Access Compliance Report Public Rights-of-Way (Island Curb Cuts)

Intersection ID: 7031 Main Street: BROOKSHIRE_BV Cross Street: OAKDALE_RD Location: NE

ADA ID: 823868A561C6 Curb Cut Type: MedianRefuge2 Initial Pass/Fail: Pass Overall Compliance: No Severity Score: 0

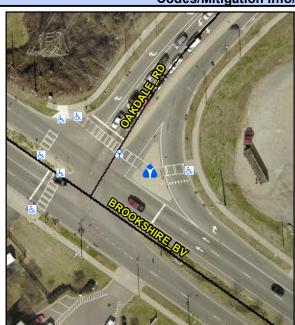
N/A Road 1 Slope (%) 2.3 Yes DWS 1 Full Width? N/A Road 1 X Slope (%) 2.8 No DWS 1 Offset (In) Yes Refuge 2 Length (In) 136.5 Yes Gutter 2 Ponding? Yes Refuge 2 Width (In) 98.0 Yes Gutter 2 Lip Ht (In) Yes Refuge 2 Slope (%) 0.2 Yes Gutter 2 Slope (%) Yes Gutter 2 X Slope (%) Yes Gutter 2 X Slope (%)	Yes 5.0 No 0.0 0.3 1.6 Yes
N/A Road 1 X Slope (%) 2.8 No DWS 1 Offset (In) Yes Refuge 2 Length (In) 136.5 Yes Gutter 2 Ponding? Yes Refuge 2 Width (In) 98.0 Yes Gutter 2 Lip Ht (In) Yes Refuge 2 Slope (%) 0.2 Yes Gutter 2 Slope (%) Yes Refuge 2 X Slope (%) 1.6 Yes Gutter 2 X Slope (%)	5.0 No 0.0 0.3 1.6 Yes
Yes Refuge 2 Length (In) 136.5 Yes Gutter 2 Ponding? Yes Refuge 2 Width (In) 98.0 Yes Gutter 2 Lip Ht (In) Yes Refuge 2 Slope (%) 0.2 Yes Gutter 2 Slope (%) Yes Refuge 2 X Slope (%) 1.6 Yes Gutter 2 X Slope (%)	No 0.0 0.3 1.6 Yes
YesRefuge 2 Width (In)98.0YesGutter 2 Lip Ht (In)YesRefuge 2 Slope (%)0.2YesGutter 2 Slope (%)YesRefuge 2 X Slope (%)1.6YesGutter 2 X Slope (%)	0.0 0.3 1.6 Yes

Remove & Replace Detectable Warning System.
